Informal document GRE-84-36 (84th GRE, 26 to 30 April 2021, agenda item 6 (a))

Japan's concerns on ECE/TRANS/WP.29/GRE/2020/4/Rev.1

A scene of the simulator experiment

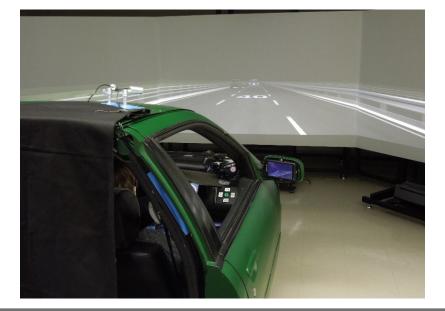
- (1) The display of road projections caused a delay in the driver's brake reaction time (on average, 0.09 s with C/O and 0.05 s without C/O for a host vehicle, 0.04 s for an oncoming vehicle, and 0.05 s for an overtaking vehicle).
- (2) RPs bothered most drivers in certain conditions if from oncoming vehicles, but not from overtaking vehicles.
- (3) On wet road surfaces, the reflective luminance of RPs seen from the host vehicle significantly decreased, but increased when seen from oncoming vehicles.
